Western Renewables Link

Inquiry and Advisory Committee Report

8 May 2026

Environment Effects Act 1978 - Inquiry report under section 9(1)

Figure 10 Height of vegetation required to screen views of 80 metre high infrastructure

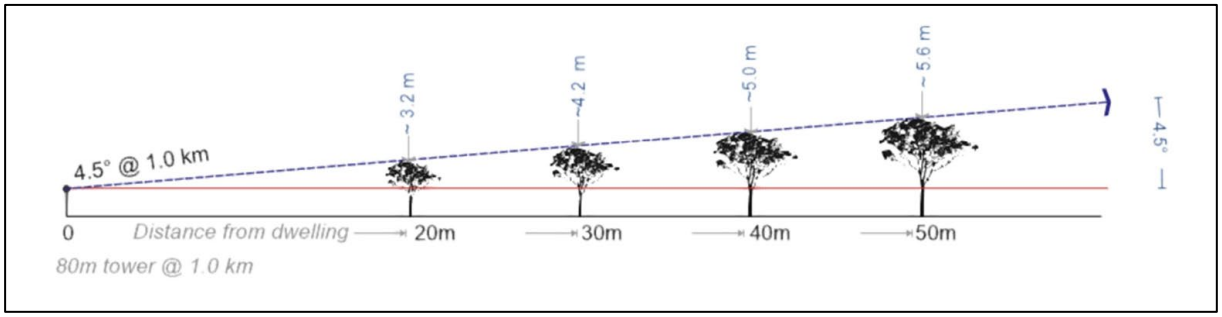
Mr Schutt and Mr Burge addressed whether landscape screening can effectively mitigate the visual impact of 80 metre high transmission towers. They explained that screening vegetation does not need to achieve a height of 80 metres to screen views of the towers. It only needs to achieve a height which interrupts lines of sight to the towers. This height decreases with distance, as demonstrated by Figure 10.

Mr Schutt and Mr Burge both noted the LVIA recognised the limitations of screening as a mitigation of visual impact, acknowledging that:

Figure 13 Photomontage – Mount Gap viewpoint

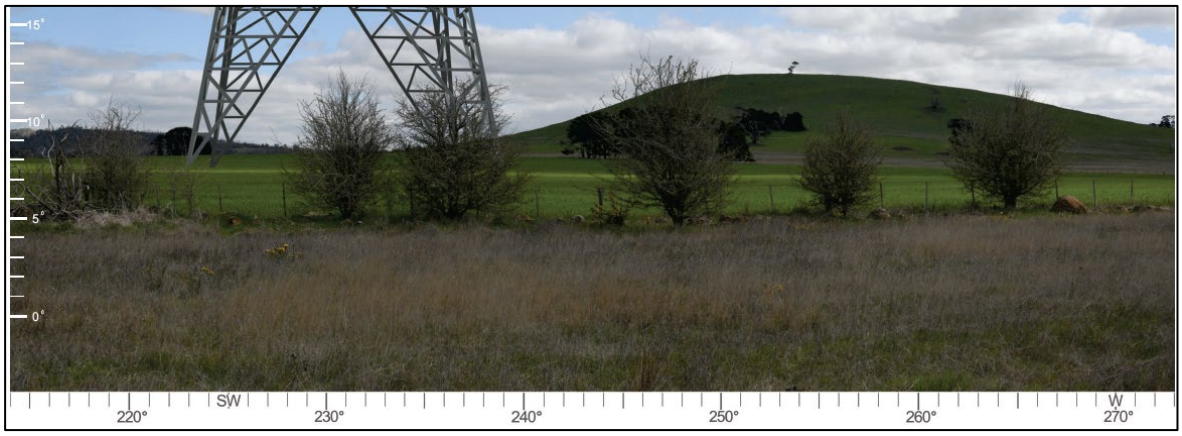
Ballarat Council was also concerned about the Project's visual impact on Mount Gap which is also protected by the SLO1 and is closer to the Proposed Route than Mount Bolton. The LVIA includes a photomontage showing the view from Coghills Creek Road to Mount Bolton (extracted in Figure 13), and assesses a 'moderate' impact (largely due to the fact that the viewpoint is on a public road and views are therefore transient). Ballarat Council submitted that based on the photomontage alone, this assessment cannot be supported.

Figure 14 Photomontage – Newlyn Reservoir viewpoint

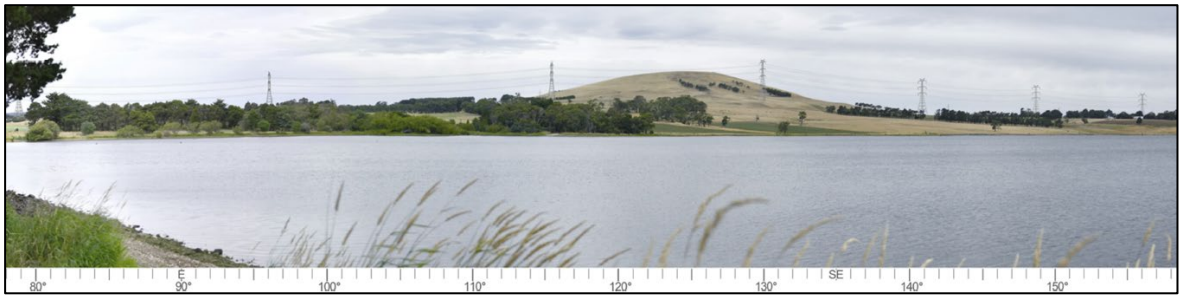
Hepburn Council disagreed with Mr Burge's assessment that the existing Bendigo transmission line (which passes by the volcanic cone) is noticeable, submitting it can barely be seen in the photomontage extracted in Figure 14. It submitted:

The IAC considers the visual impact of the Project on views from the western shoreline of Newlyn Reservoir should be rated as at least 'high', not 'moderate'. The photomontage extracted in Figure 14 demonstrates that the towers will be highly visible, sitting above the horizon with little to no screening from existing vegetation. The IAC does not consider they are fairly described as a 'background element' in this view. Further, the LVIA described viewer type and numbers at Newlyn Reservoir as 'Tourist – High'.

While the towers will represent a dominant element in the landscape and in views from the Reservoir toward Mount Bullarook, the photomontage in Figure 14 demonstrates that relationship between the Reservoir and Mount Bullarook can still be seen and understood. Further, the IAC accepts the finding in the LVIA that not all views across the Reservoir will be impacted by the Project. Views to the west and south west will remain uninterrupted, although the landscapes to the west and south are not identified as significant.

Figure 19 Landscape type classifications in the Darley, Long Forest Coimadai area

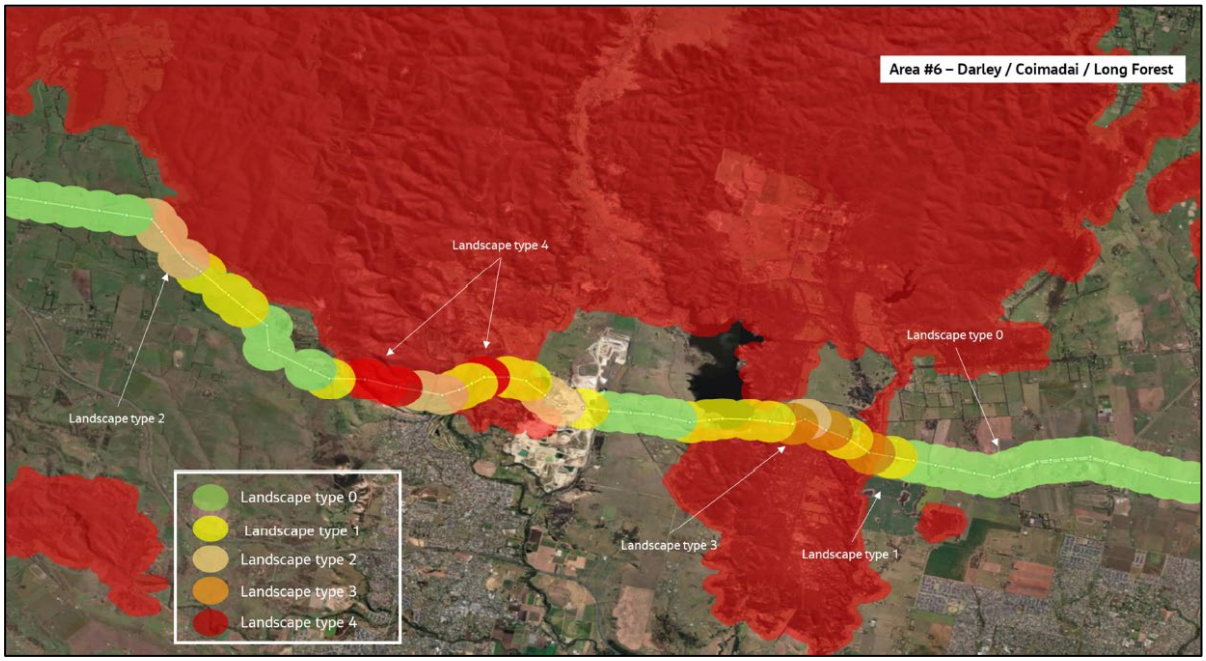
The urban parts of Darley have high population numbers that extend right to the edge of the landscape type 4 extreme bushfire risk areas, as Figure 19 demonstrates. The IAC accepts that if a fire was approaching from the north, multiple egress routes would be available to the south toward safe places in Bacchus Marsh. However no analysis was presented on how quickly this area could be evacuated if a fire was approaching (from any direction).

Figure 22 Transmission towers in proximity to Melton Aerodrome

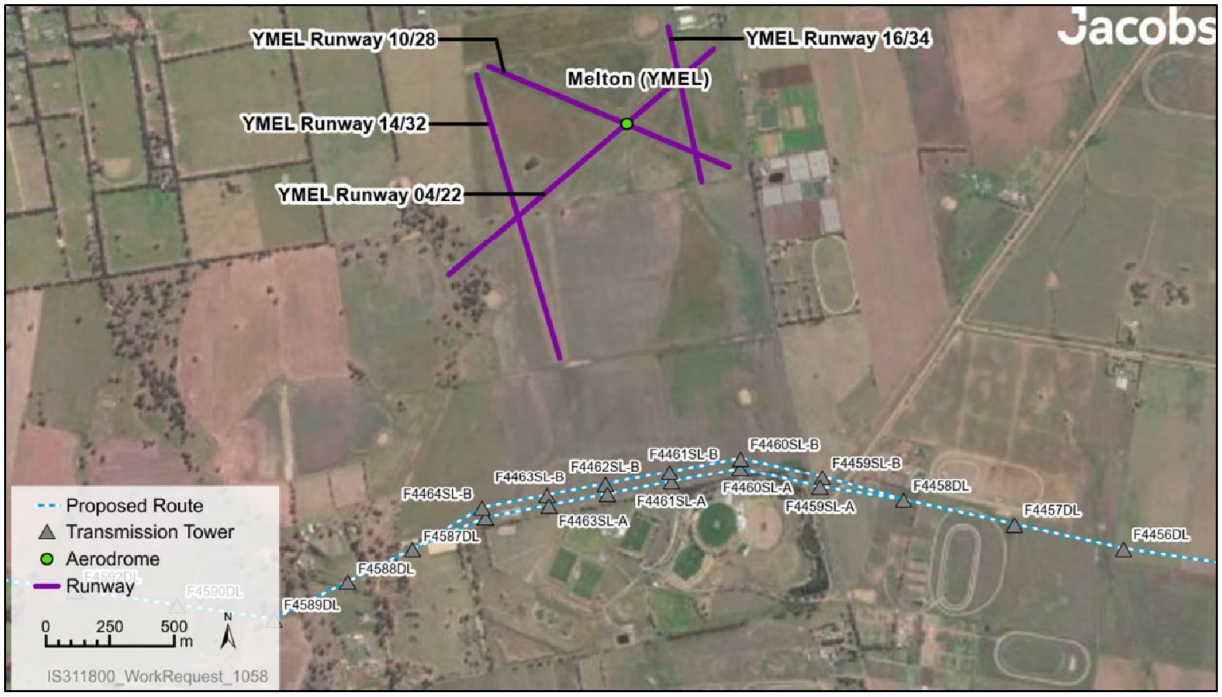
The EES noted that the nominal 85 metre high double circuit towers used for the Project would have significant impacts on the operation of the aerodrome. Consequently, the towers in this area include lower single circuit towers ranging from 33.76 to 39.62 metres in height (between towers F4459SL-A and F4464SL-B). The height of the connecting double circuit towers either side (F4458DL to the east and F4588DL to F4595DL to the west) were also reduced from the standard tower heights, ranging from 60.9 to 69.9 metres tall. The location of these towers are shown in Figure 22.

Figure 25 Proposed Route and potential underground route options at Darley

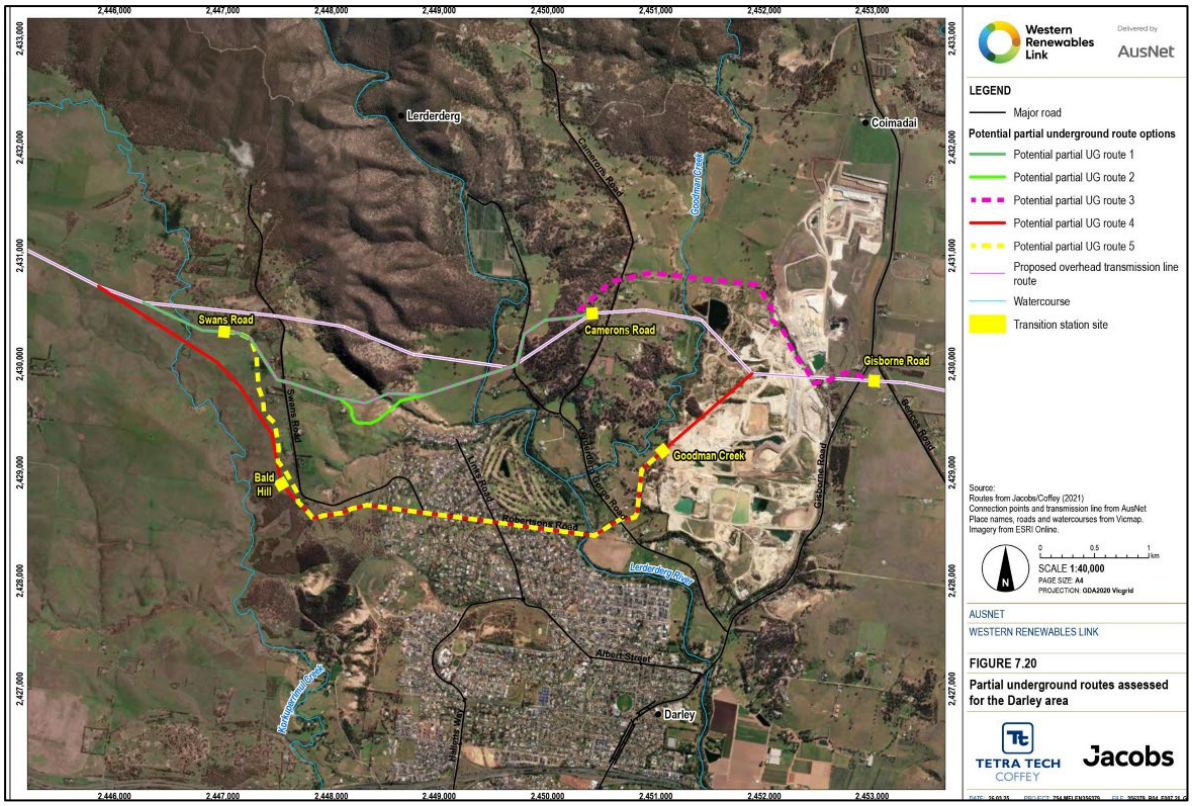
The EES recognised the area around Darley is highly constrained. EES Attachment 1 explained that the Darley area warranted an investigation of partial undergrounding options due to:

EES Attachment I assessed five alternative underground route options through Darley, which are shown in Figure 25. After assessing the underground alternatives, it concluded:
